ADDENDUM No. 2
SECTION 00 91 13

PROJECT: **PROJECT OFFICE BUILDING,
RENOVATION OF EXISTING BUILDING, AND
SITE IMPROVEMENTS AT FOXWORTH,
MARION COUNTY, MISSISSIPPI**

PROJECT NUMBERS: **BWO-7149-46(001) 502689**
BWO-7079-46(003) 502689
LWO-7061-46(003) 502689

DATE: **APRIL 15, 2016**

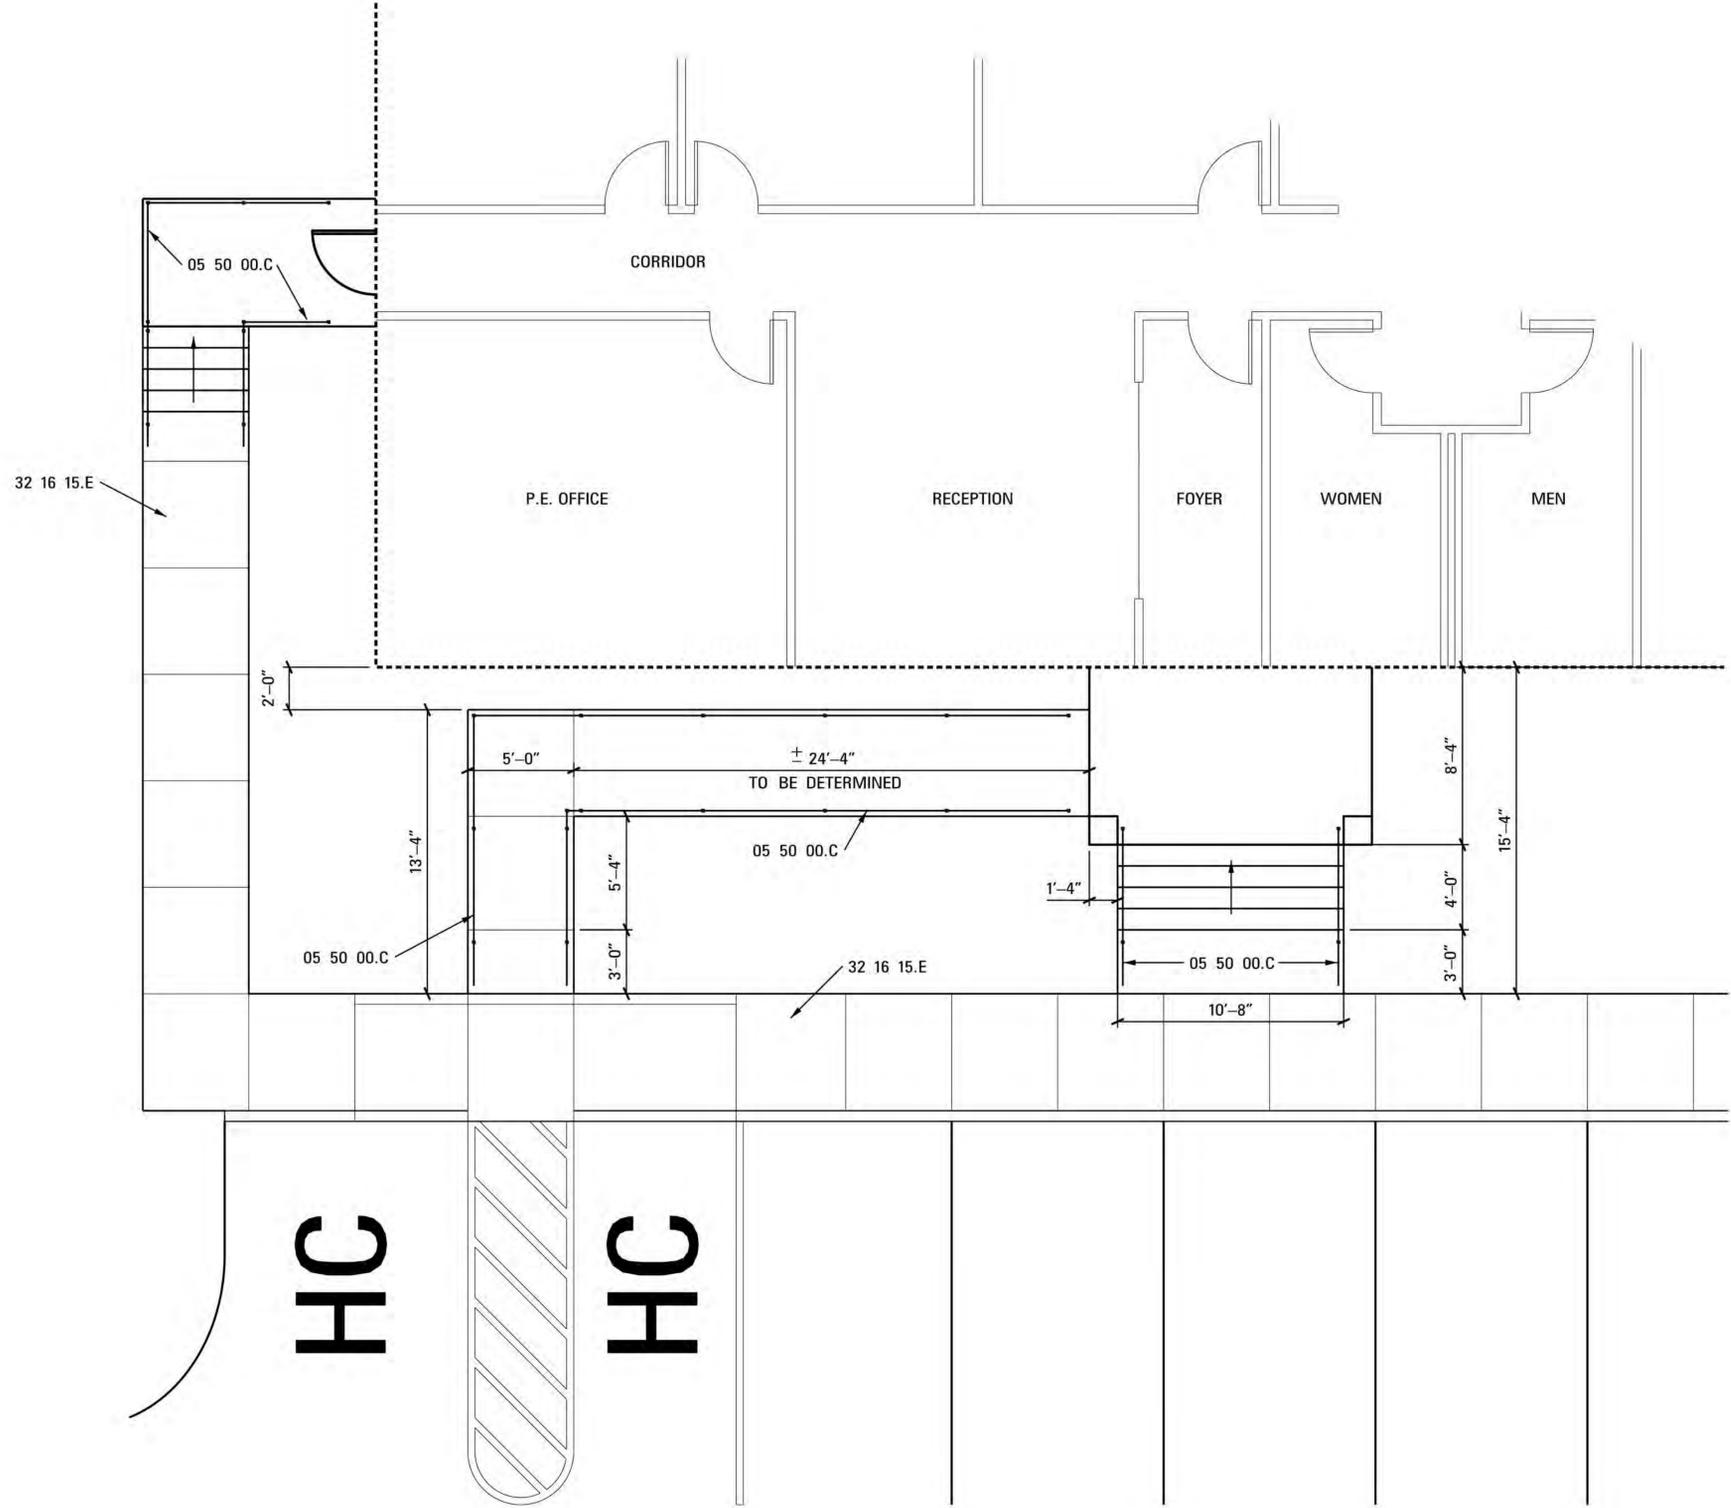
- E. The following revisions have been made to Working Number C1.5, Sheet Number 7:
 - 1. Revisions to utilities servicing building.
- F. The following revisions have been made to Working Number C1.6, Sheet Number 8:
 - 1. Added step, handicap ramp, and railing details to Drawing.
- G. The following revisions have been made to Working Number A1.1, Sheet Number 12:
 - 1. Revision of building location and addition of steps and handicap ramp to Overall Site Plan.
- H. Working Number S5.2, Sheet Number 25.1 added to Drawings to show detailed plan of handicap ramp and steps with handrails.
